ORIGINATION FORM

Proposed Revisions to a Standard Plans Index

Index Number: 715-010

Index Title: HIGH MAST LIGHTING

LAST REVISION 11/01/18	REVISION	DESCRIPTION:		FY 2023-24 STANDARD PLANS	HIGH MAST LIGHTING	INDEX 715-010	SHEET 1 of 6
--------------------------------------	----------	--------------	---	------------------------------	--------------------	------------------	-----------------

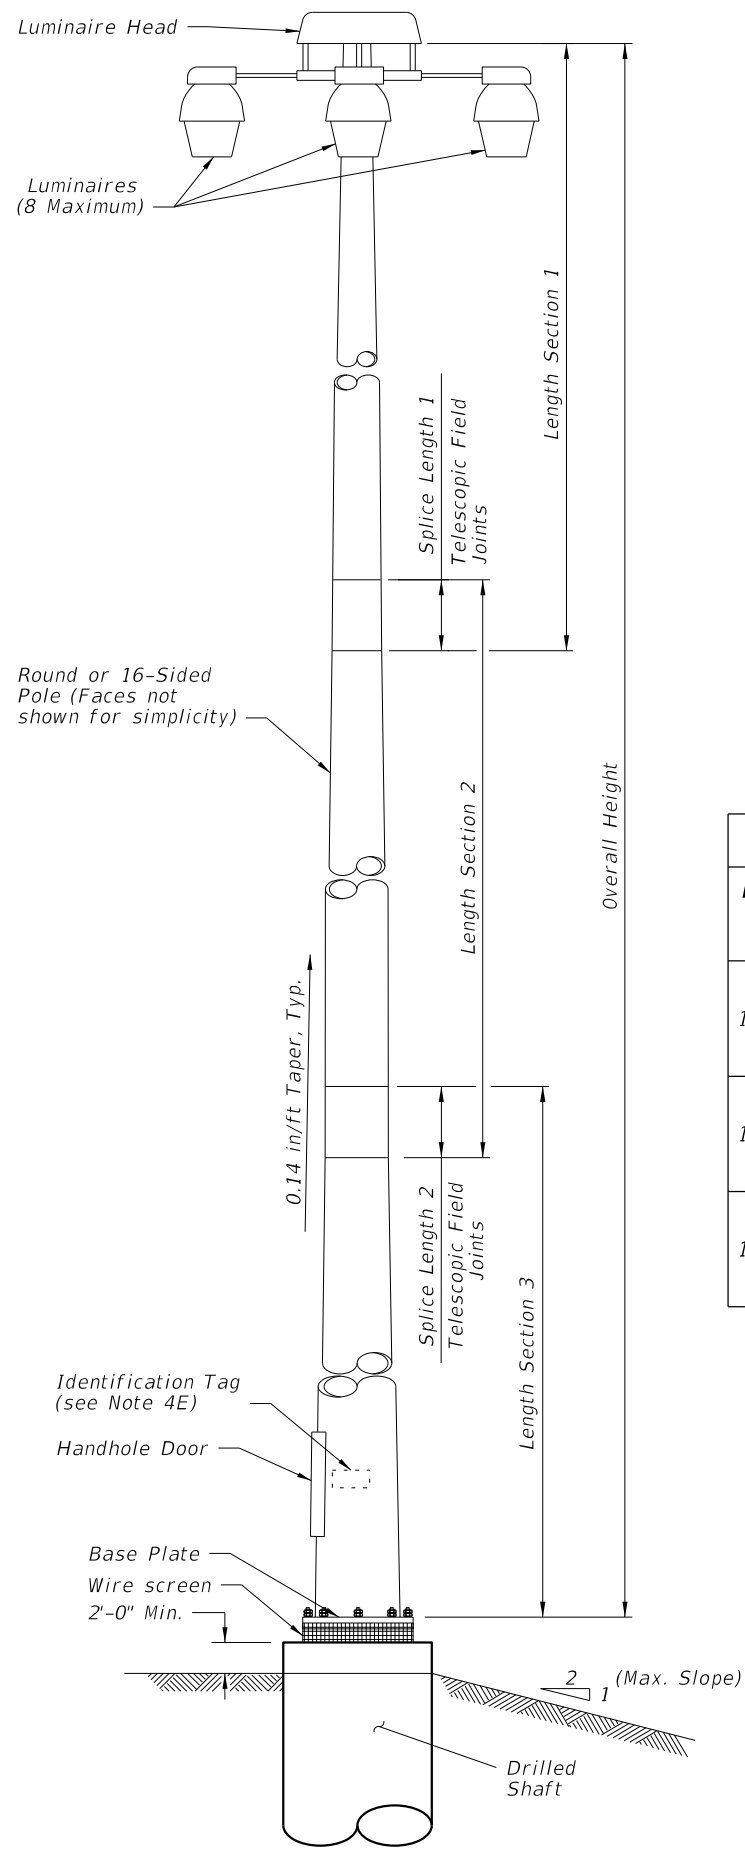
Sheet 1: Changed phrase from "full-penetration groove" to "complete joint penetration".

Sheet 1: Changing non-standard language to standard language consistent with AWS.

complete joint penetration

INDEX	SHEET
715-010	3 of 6

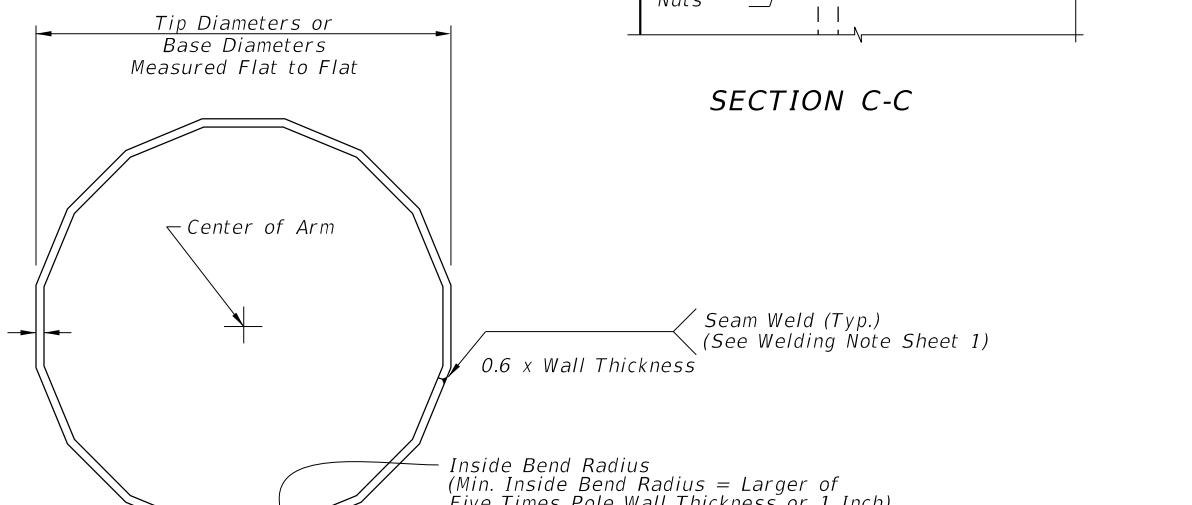
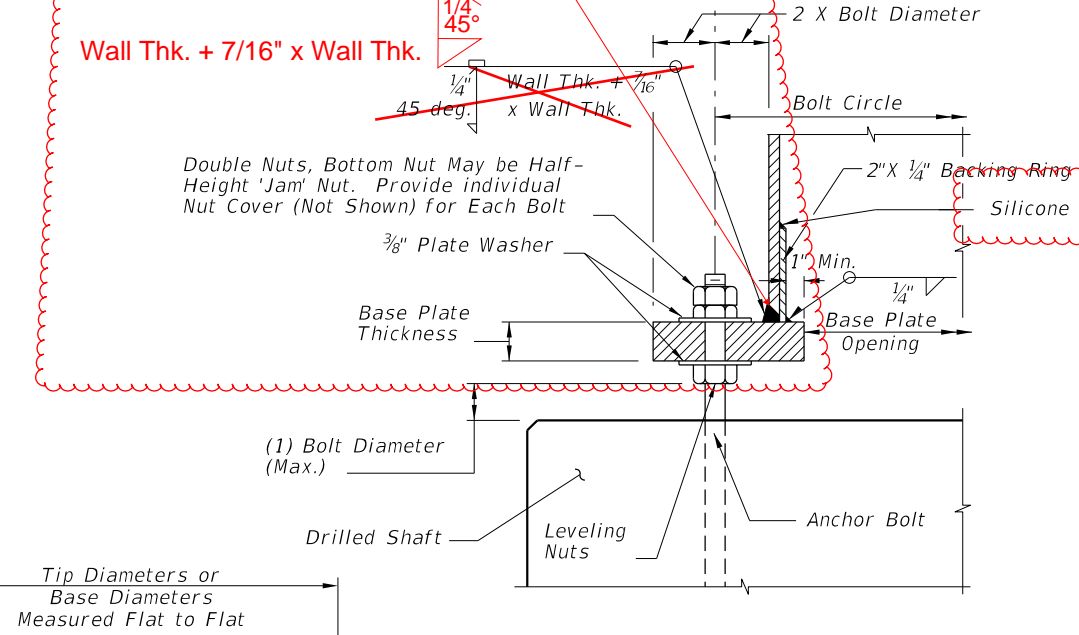
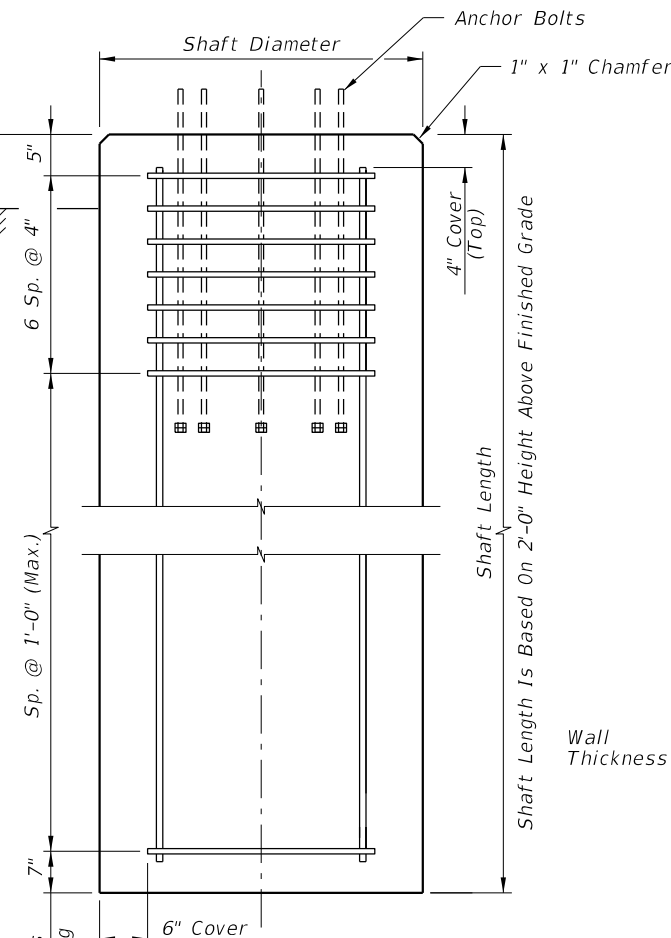
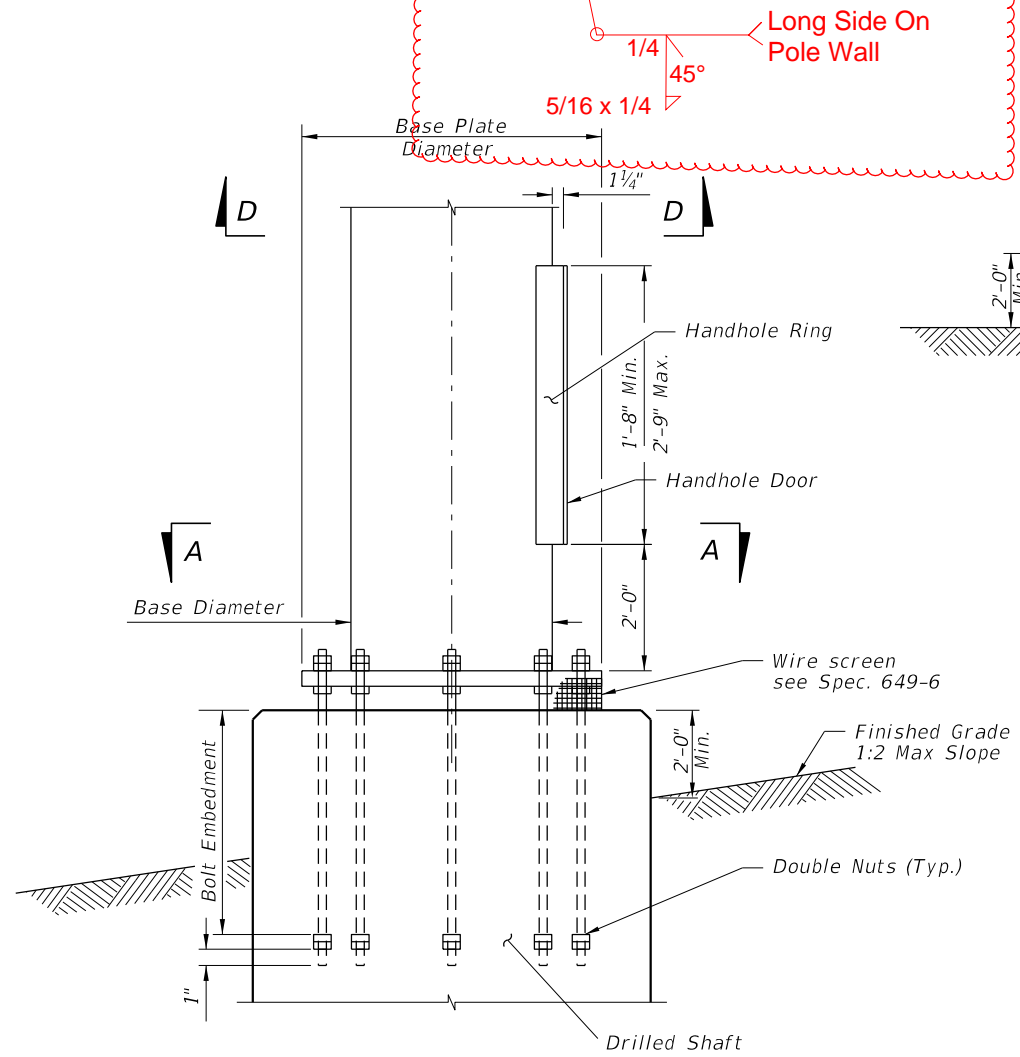
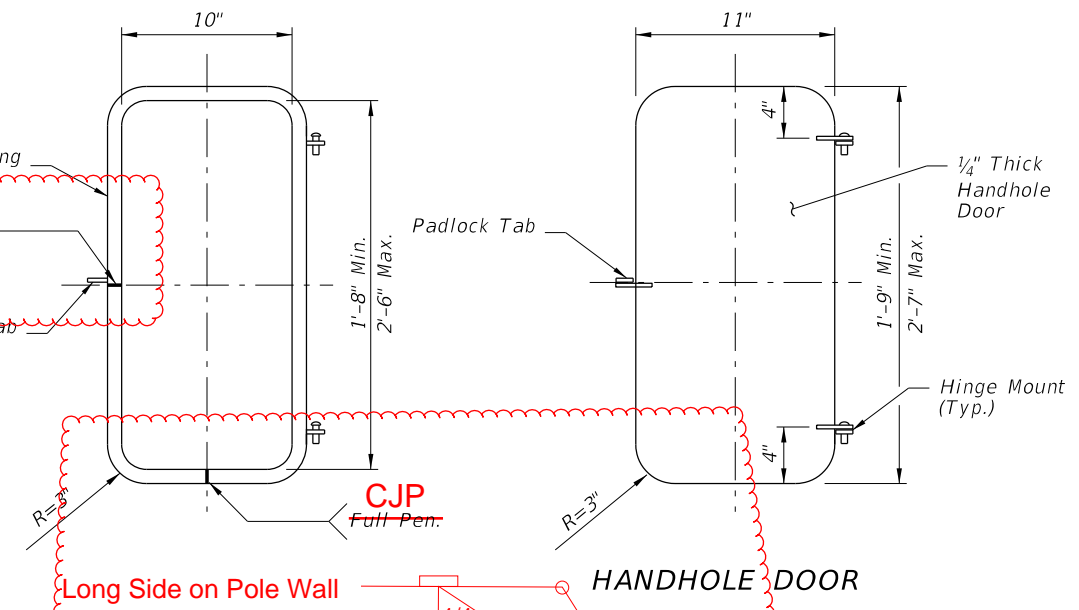
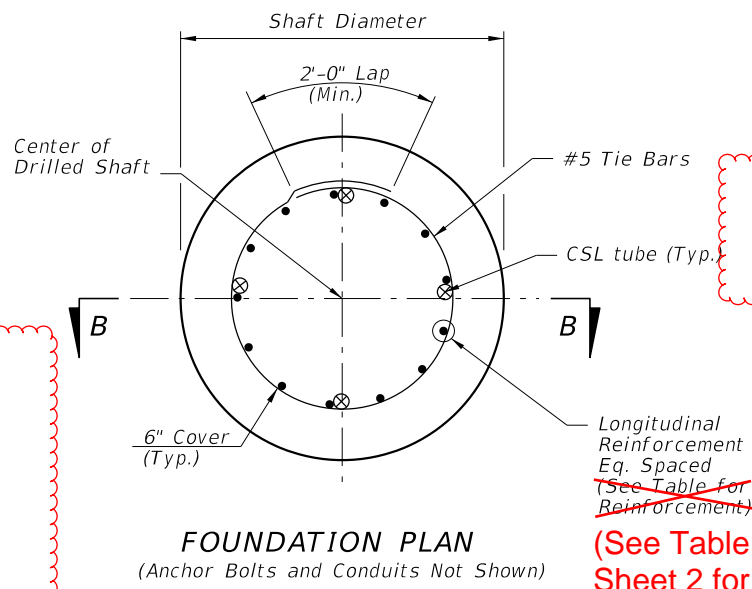
Sheet 3: Corrected the welding arrows on Section A-A and C-C to be consistent with AWS; Added note to Section CC that silicone caulk should be done after galvanizing; Changed weld detail to say "CJP."

Sheet 3: During a review of a fabricators QC Plan it was found that the Standards welding symbols were not formatted correctly. We corrected this to be consistent with AWS; Changed non-standard language about penetration welds to standard language consistent with AWS.
